UNITED STATES PATENT AND TRADEMARK OFFICE

APPLICATION NO.	FILING DATE	FIRST NAMED INVENTOR	ATTORNEY DOCKET NO.	CONFIRMATION NO.
10/717,415	11/19/2003	Gunnar Behrens	HK-815	7259
24131	7590	11/27/2007	EXAMINER	
LERNER GREENBERG STEMER LLP			MORRISON, THOMAS A	
P O BOX 2480			ART UNIT	PAPER NUMBER
HOLLYWOOD, FL 33022-2480			3653	
MAIL DATE		DELIVERY MODE		
11/27/2007		PAPER

Office Action Summary	Application No.	Applicant(s)
	10/717,415	BEHRENS ET AL.
	Examiner	Art Unit
	Thomas A. Morrison	3653

DETAILED ACTION

FIG.2

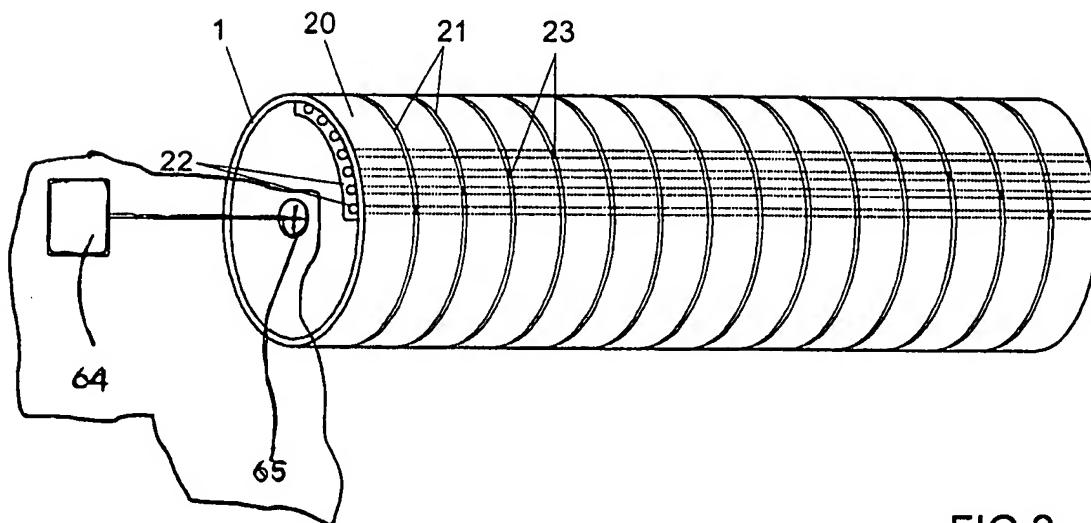
1. Applicant's amendments to the specification and claims filed on September 5, 2007 have been entered.
2. The drawing was received on 9/5/2007. This drawing (i.e., new Figure 2) has not been entered, because it introduces new matter. In particular, new Fig. 2 shows details of how a vacuum pump 64 is arranged and connected to an exposure drum 1, which is not supported by the disclosure of the instant application. Thus, the new drawing (i.e., Fig. 2) has not been entered.
3. This application is in condition for allowance except for the following formal matters:

4. The drawings are objected to under 37 CFR 1.83(a). The drawings must show every feature of the invention specified in the claims. Therefore, (1) the vacuum pump recited in claim 1 must be shown or the feature(s) canceled from the claim(s). No new matter should be entered.

One possible acceptable new Figure 2 would include (1) the recited vacuum pump of claim 1 shown as a **box labeled "64"**; (2) the rotary lead-through 65 of the specification shown as **another box labeled "65"**; (3) a line connecting the box labeled "64" to the box labeled "65"; and (4) a line connecting the box labeled "65" to the center of the exposure drum 1.

FIG.2

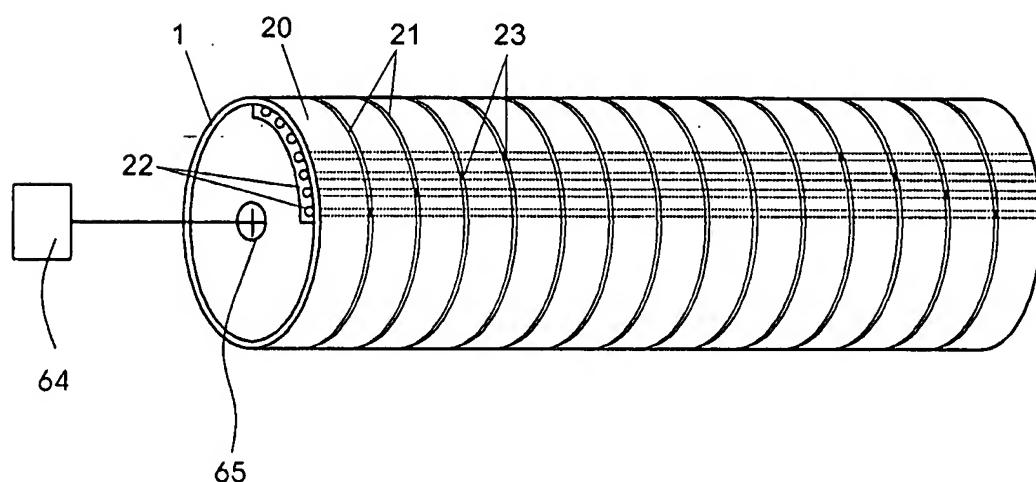
Do Not Enter
11/25/07
